# Super-PON Draft Updates

IEEE P802.3cs, April 02, 2020  
Liang Du (Google)

# OLT transmit

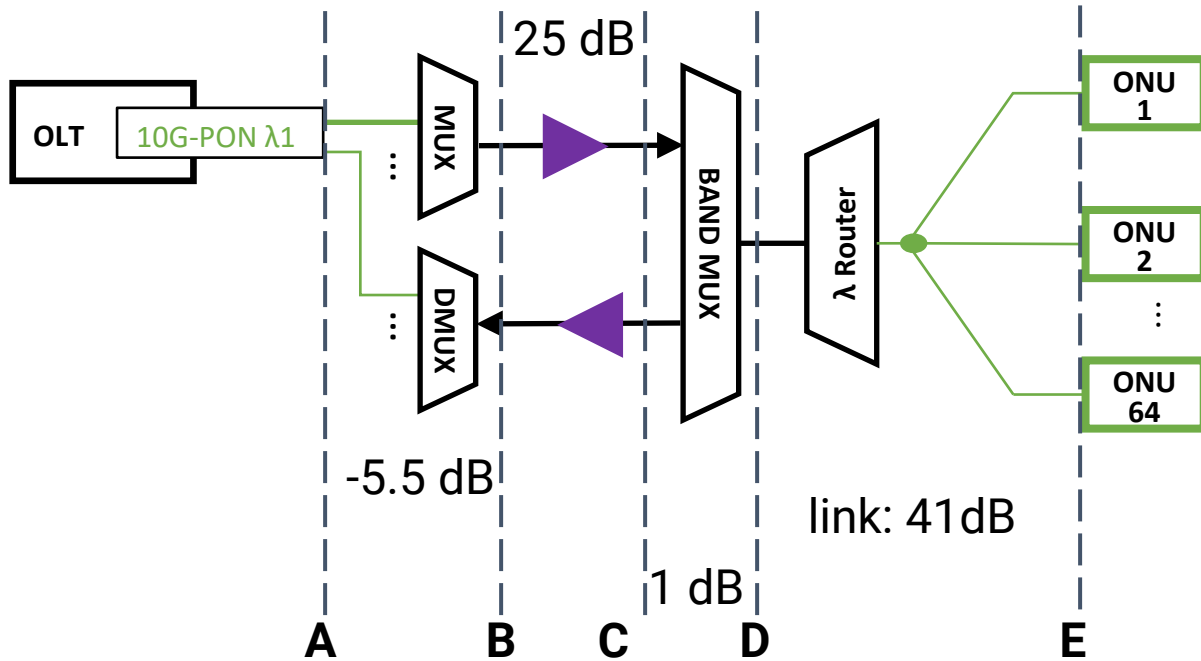
<b>Current draft values</b>	<b>Updated values for next draft</b>	
<b>Parameter</b>	<b>10GBASE-SP1-Dx 10/2.5GBASE-SP1-Dx</b>	<b>10GBASE-SP1-Dx 10/2.5GBASE-SP1-Dx</b>	<b>Unit</b>
Signaling speed (range)	10.3125 ± 100 ppm	10.3125 ± 100 ppm	GBd
Channel center frequencies	L-band 1 (downstream)	C-band 1 (downstream)	THz
Maximum spectral excursion	± 12.5	± 12.5	GHz
Maximum mean channel output power	2	1.5	dBm
Minimum mean channel output power	-3	-2.5	dBm
Minimum side-mode suppression ratio (SMSR)	35	35	dB
Minimum channel extinction ratio	8.2	8.2	dB
Transmitter eye mask definition {X1, X2, X3, Y1, Y2, Y3}	{0.25, 0.4, 0.45, 0.25, 0.28, 0.4}	{0.25, 0.4, 0.45, 0.25, 0.28, 0.4}	UI
Transmitter and dispersion penalty (TDP) @ 0 to 1000 ps/nm residual CD	0*	0*	dB
RIN <sub>15</sub> OMA (max)	-120	-120	dB/Hz
Average launch power of OFF transmitter (max)	-39	-39	dBm
Optical return loss tolerance (max)	15	15	dB

# OLT receive

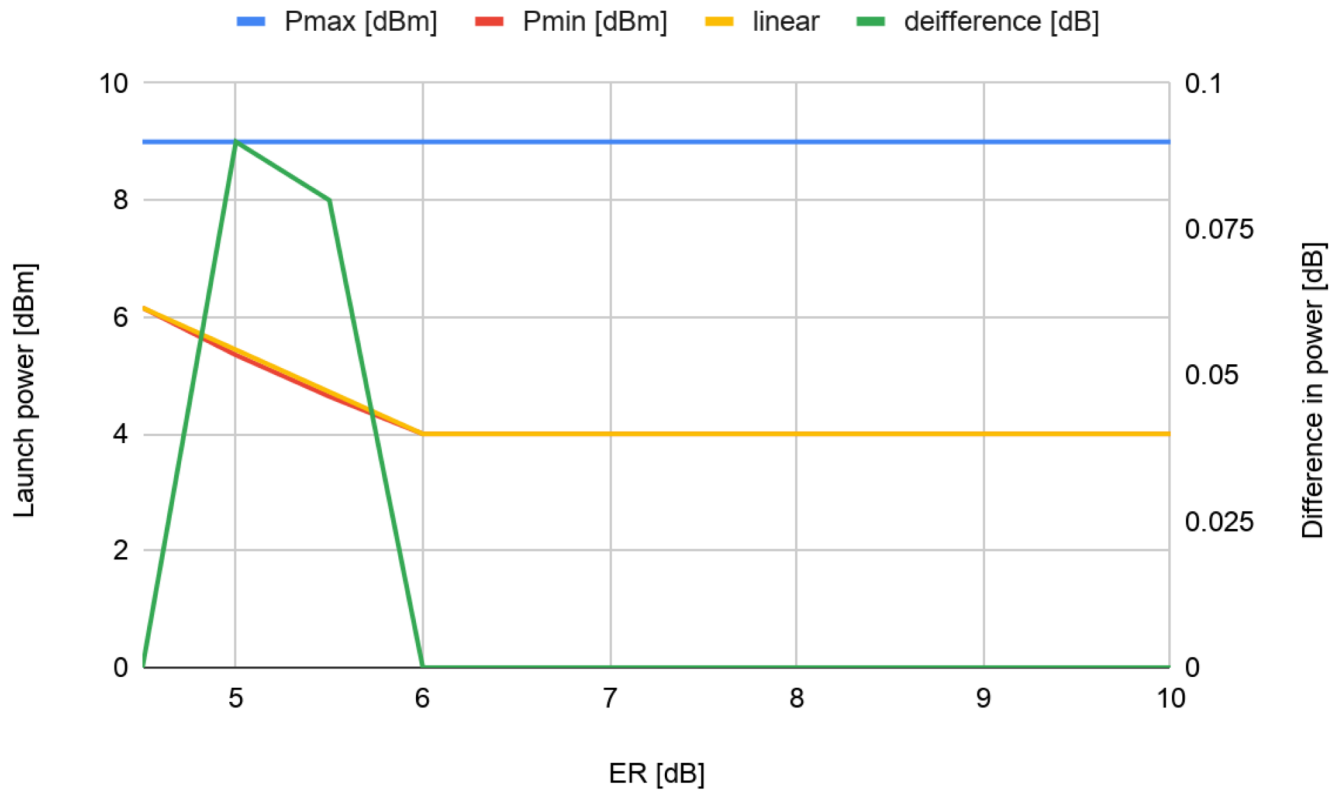
Parameter	Current draft values		Updated values for next draft		Unit
	10GBASE-SP1-Dx	10/2.5GBASE-SP1-Dx	10GBASE-SP1-Dx	10/2.5GBASE-SP1-Dx	
Signaling speed (range)	10.3125 ± 100 ppm	2.578125 ± 100 ppm	10.3125 ± 100 ppm	2.578125 ± 100 ppm	GBd
Channel frequency range	191.990 to 193.510		187.600 to 189.092		THz
Bit error ratio (max)	10 <sup>-3</sup>		10 <sup>-2</sup>		
Maximum mean input power	-6		-6		dBm
Minimum mean input power	-23	-26	-20.6	-25.1	dBm
Minimum OSNR			15	10.5	dB (0.1 nm)
Receiver OSNR tolerance			12.9	8.4	dB (0.1 nm)
Receiver reflectance (max)	-12		-12		dB
Damage Threshold	-5		-5		dBm
Signal detect threshold (min)	-45		-45		dBm
Treceiver settling (max)	800		800		ns

# Power vs ER curves

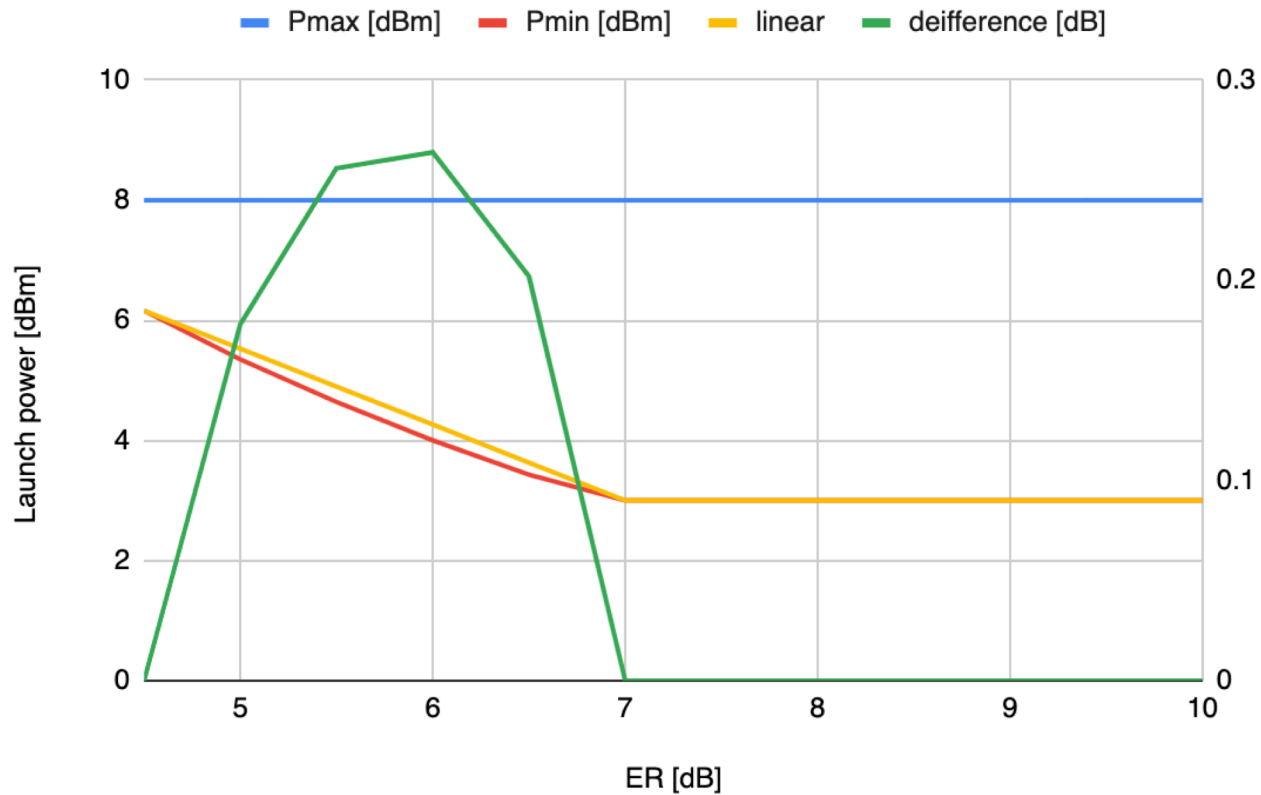
- Max power of 8 dBm
- Allows for 3 dBm at ER  $\geq 7$  dB ----> Better for EML ONUs

ER (dB)	Pmax [dBm]	Pmin [dBm]	linear
10	8	3	3
9.5	8	3	3
9	8	3	3
8.5	8	3	3
8	8	3	3
7.5	8	3	3
7	8	3	3
6.5	8	3.43	3.632
6	8	4	4.264
5.5	8	4.64	4.896
5	8	5.35	5.528
4.5	8	6.16	6.16

- Equation xx:
  - $P_{\min} = -1.44 * ER + 12.64$  for  $4.5 \leq ER \leq 6$
  - $P_{\min} = -ER + 10$  for  $6 \leq ER \leq 7$
  - $P_{\min} = 3$  for  $ER \geq 7$
